**BCA & ACCESS CAPABILITY STATEMENT
ISSUED FOR DEVELOPMENT APPLICATION**

EXP CAPITAL – CHILDCARE CENTRE

RYANS ROAD GILLIESTON HEIGHTS, NSW 2321.

Reference/Revision	Date		
241115-Capability Statement-r1 Issued for DA	02/02/2024	Prepared by	<div>Zoe Brown Building Surveyor – Unrestricted (A1) BDC 3299</div> <div> Digitally signed by Zoe Brown Date: 2025.02.02 17:35:34+11'00'</div>

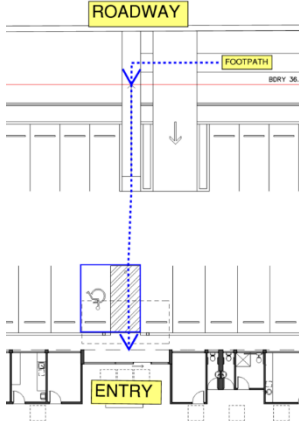
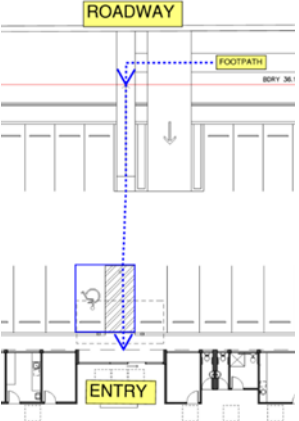
Clause D4D3(1) of the BCA specifies accessible points of entry into the building and site. The accessways must comply with AS 1428.1 and for the purposes of this assessment, the following accessways are required

<p>D4D3 (1) a) The main points of pedestrian entrance into the site at the allotment boundary;</p>	<p>An accessway into the building from the pedestrian entrance into the site at the northern boundary must be provided. The entry location is indicated on the markup below.</p>  <p><i>Figure 1 Mark-up of the site entrance to the building required to be accessible Source: Shaddock Architect</i></p>
<p>D4D3 (1) b) Another accessible building connected by a pedestrian link;</p>	<p>The proposal does not contain a pedestrian link or connection to another building and therefore an assessment against this provision is not applicable.</p>
<p>D4D3 (1) c) Any required accessible carparking space on the allotment.</p>	<p>An accessway into the building from the accessible car spaces located on the allotment to the north on the subject building as marked up below.</p>  <p><i>Figure 1 Mark-up of the pedestrian link from the carpark to the building required to be accessible Source: Shaddock Architect</i></p>

Figure | Mark-up of the entrance doors required to be accessible |Source: Shaddock architect

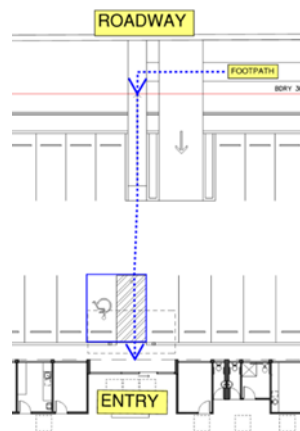
For the purposes of Clause D4D3(2) of the BCA, the following pedestrian doors are required to be accessible:

- Main entry door on the northern façade which adjoins Unnamed roadway via Ryans Road.

Note: Not less than 50% of pedestrian doors are required to be accessible; and as the building contains a floor area of more than 500 m² any entrance which is not accessible cannot be located more than 50m from an accessible entrance.
